March 14, 2007

**American Honda Motor Co., Inc.  
Acura Automobile Division**

## Safety Recall: Fuel Pump Relay May Cause Engine No-Start or Stalling

**PGM-FI MAIN RELAY 2 (FUEL PUMP)**  
 (The RL relay is shown.  
 Other models are similar.)

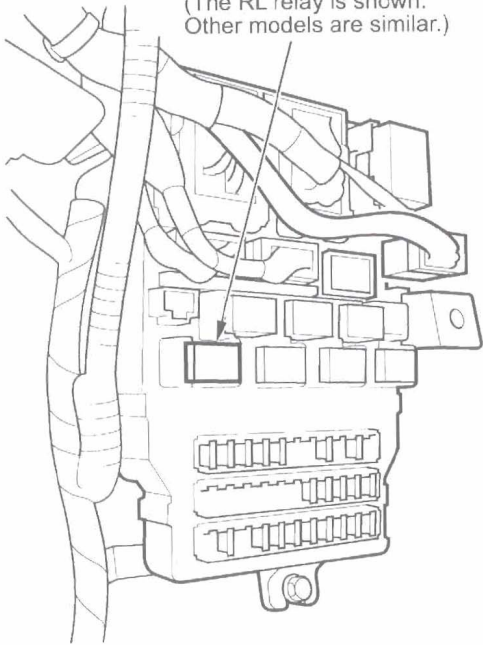
- Locate PGM-FI Main Relay 2 (Fuel Pump) in the under-dash fuse/relay box: Look at the name printed on the relay.

**DENSO RELAY**  
 (Do not replace.)

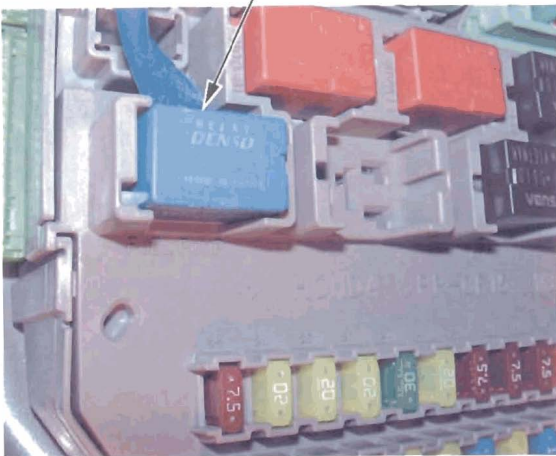
- If the name is **DENSO**, the relay is OK. Go to step 6.

**MITSUBARELAY**  
 (Replace it if the vehicle is shown as eligible on a VIN status inquiry.)

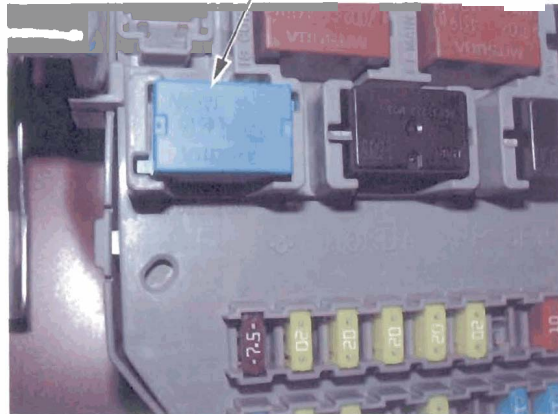
- If the name is **mitsuba**, and the vehicle is not shown as eligible on a VIN status inquiry, go to step 6.
- If the name is **MITSUBA**, and the vehicle is shown as eligible on a VIN status inquiry, go to step 4.

NOTE: MITSUBA may be printed upside down.

- Remove the relay.  
 NOTE: Since the relay will not be reused, it's OK to remove it with pliers.
- Press the new relay into place on the fuse/relay box.
- Reinstall the left kick panel and the left front door sill trim.
- Center-punch a completion mark above the third character of the engine compartment VIN.
